Puente Hills Habitat Preservation Authority

Addendum #1, 9/27/2021 Request for Bids Tree Removal Scope of Work

Puente Hills Fuel Reduction Project- Tree Removal RFP

Addendum #1 (September 27, 2021)

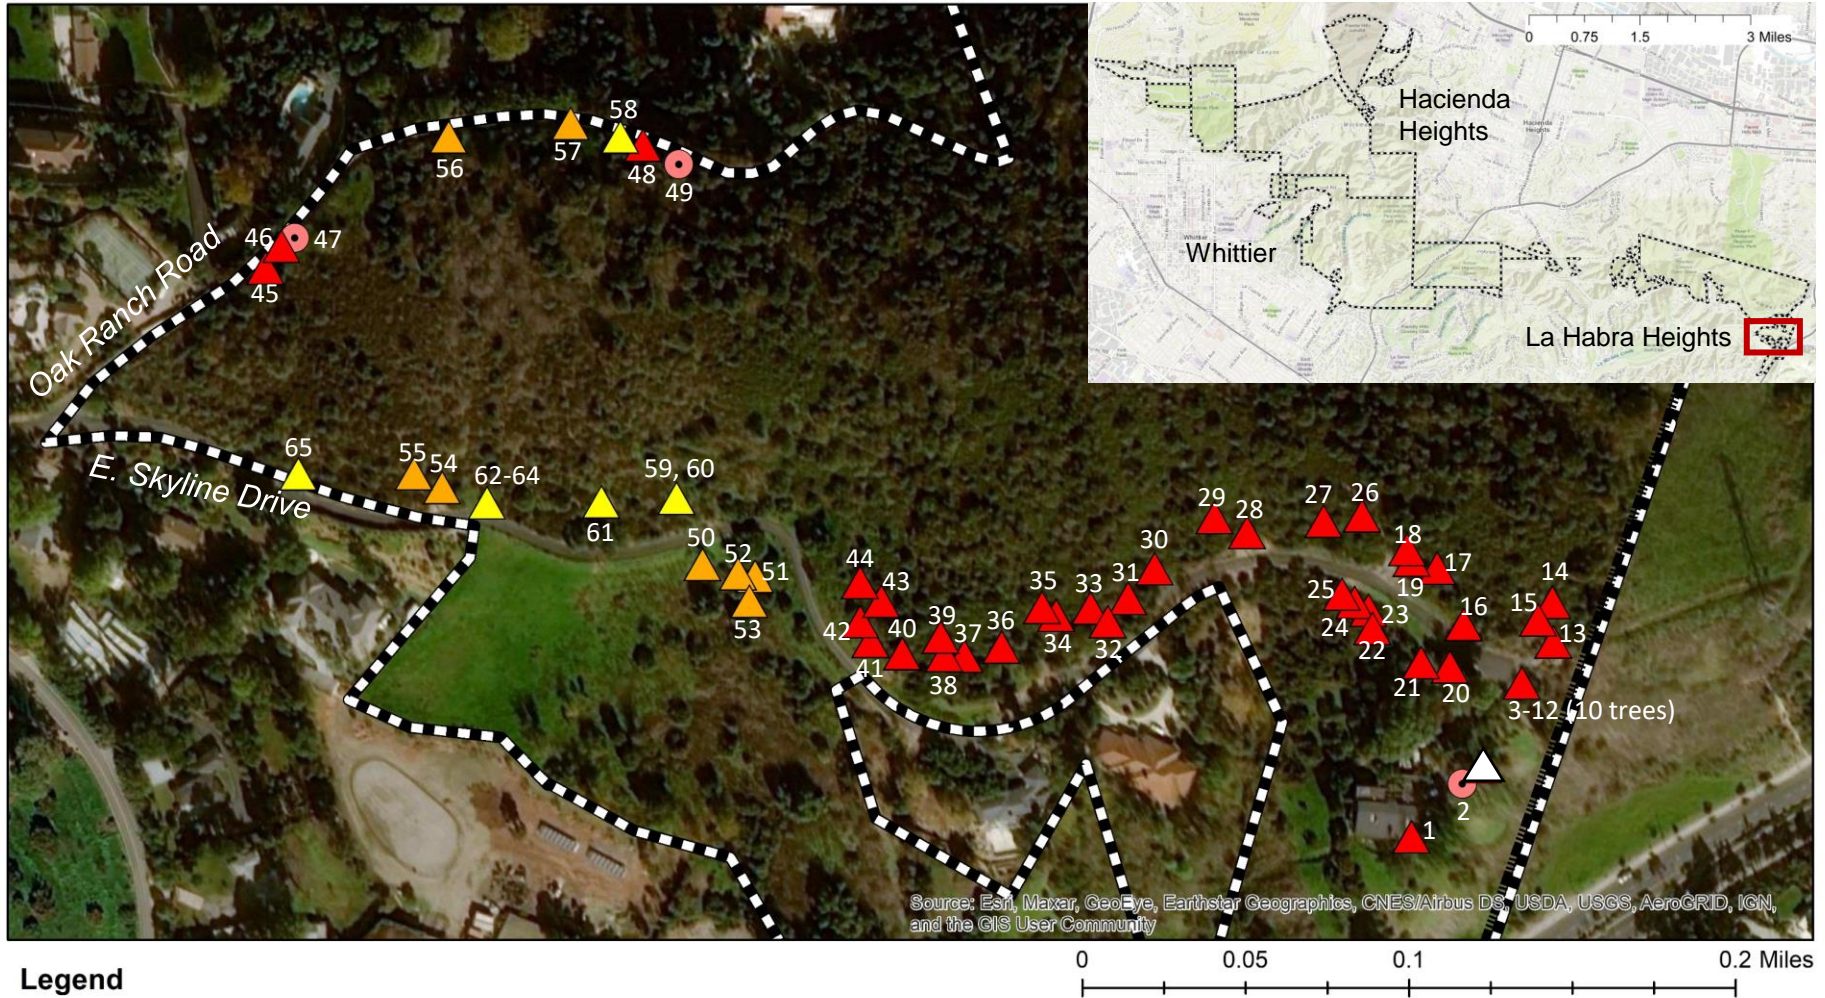
- 1. The new bid deadline is 10 am on October 7, 2021.** Bids are due two (2) hours earlier than originally stated.
- 2. Include the revised map of trees with your bid.** Use the attached revised map to identify which trees you plan to remove with your bid. Also, the trees have been numbered in priority to assist you in this effort.

- 3. Bids should identify which trees can be removed/trimmed starting with #1 in priority order.** Trees located furthest to the east on Skyline Drive are the highest priority (trees labelled #1-44 on attached map). Mark on the map in your bid which trees are targeted for removal starting from *east to west*. The next highest Priority 1 level trees are on Oak Ranch Road, starting from *west to east* (trees labelled #45-49 on map). Priority 1 level trees are higher ranked than Priority 2 or Priority 3 trees.

- 4. Use the Revised Bid Sheet, attached.**
- 5. Changes to three trees on the revised map:**
 - a) A tree that was previously identified for trimming on Oak Ranch Rd, now needs to be **removed**. Upon inspection today, it was dead and fallen over. Please see the revised map (labeled #45). It is the western most tree on Oak Ranch Road. See below photo.

- b) **A large eucalyptus tree along the ranger residence driveway slated for removal has been changed to not be removed or trimmed at all.** This tree is adjacent to the eucalyptus that will be trimmed. See revised map.

- c) A large eucalyptus tree along the ranger residence driveway slated for removal has been changed to **trim only**. Only material hanging over the driveway will be trimmed.
